A RESOLUTION RECEIVING ADDITIONAL PUBLIC COMMENTS ON A
REVISED DESIGN FOR SMITH LEVEL ROAD IMPROVEMENTS

RE: Smith Level Road (TIP #U-2803): April 27, 2010, public hearing follow-up report

SUBJECT: Smith Level Road (TIP Project U-2803)

Figure 2. FHWA recommendations for orienting the approach to a roundabout. Source: FHWA 2000.¹²

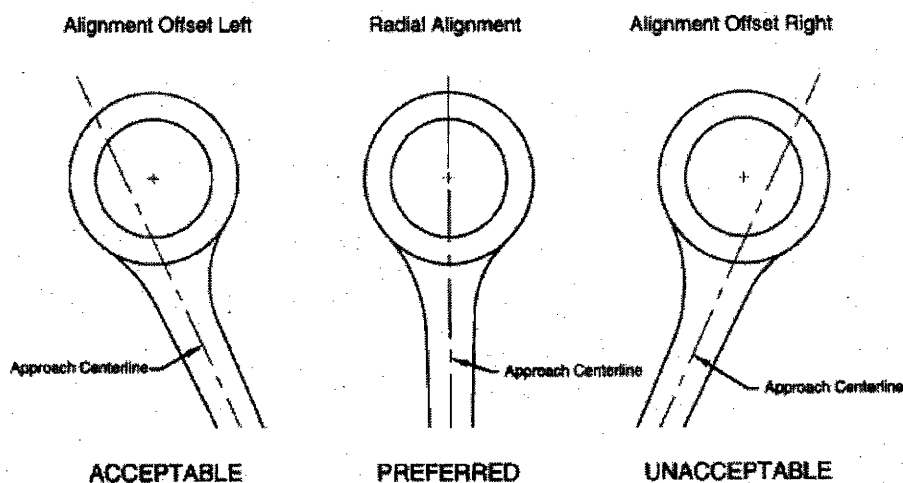
The fact that roundabouts require vehicles to travel a curved path is important to their ability to reduce speeds. The Federal Highway Administration (FHWA) recommends that the approach centerline go right through the center of the roundabout, or be at least slightly offset to the left. This is to ensure that vehicles have to turn a fair amount and are not able to speed through the roundabout at a tangent with only a slight turn of the steering wheel.¹¹ (See Figure 2.) The Transportation Advisory Board recommends that the splitter island at the proposed Smith Level/Rock Haven roundabout be modified to increase vehicle deflection and decrease the curve radius, necessitating a sharper, slower turn (Attachment C).

5. We are in favor of the construction of the roundabout, but we would like to see it modified in order to increase the deflection of the approaches (see Attachment A).

Figure 15: Design of the kerblines of the splitter island

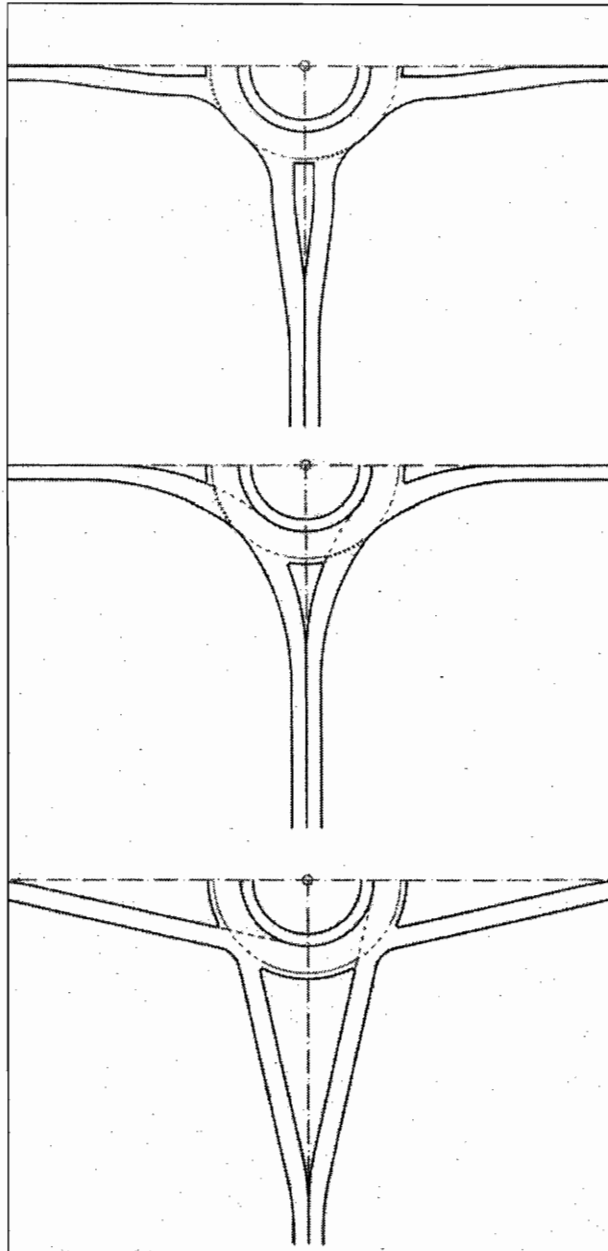
If there is a (very) wide splitter island or refuge ($> 3\text{m}$, which can be beneficial to the capacity, see section 4.7), it is advisable to increase the diameter of the roundabout in order to create enough deflection on entry. Up to 30 m, the outer radius of a roundabout has little influence on speed and therefore on road safety.
